UNITED STATES PATENT AND TRADEMARK OFFICE

APPLICATION NO.	FILING DATE	FIRST NAMED INVENTOR	ATTORNEY DOCKET NO.	CONFIRMATION NO.
10/620,360	07/17/2003	Chung-Fan Chiou	Q76519	8933
23373	7590	03/07/2006	EXAMINER	
SUGHRUE MION, PLLC 2100 PENNSYLVANIA AVENUE, N.W. SUITE 800 WASHINGTON, DC 20037			LEVKOVICH, NATALIA A	
			ART UNIT	PAPER NUMBER
			1743

Office Action Summary	Application No.	Applicant(s)	
	10/620,360	CHIOU ET AL.	
	Examiner	Art Unit	
	Natalia Levkovich	1743

DETAILED ACTION

FIG. 2

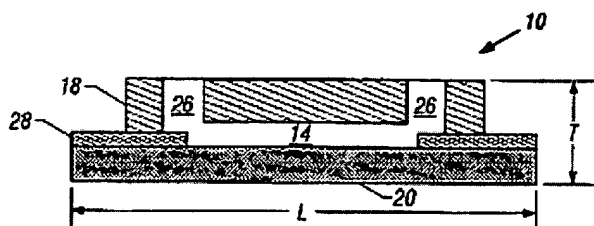
Zhao discloses a micro-fluidic chip which includes substrate 18 ['second member' – Ex.] comprising micro-channel 14 ['fillister' – Ex.], cover 20 ['first member' – Ex.] and electrodes 28 located both on the cover and in reservoirs 14 and 26 (see Figure 2).

Referring to claims, 5 and 20, Figure 2 also shows wells 26 [‘at least two openings’ – Ex.].
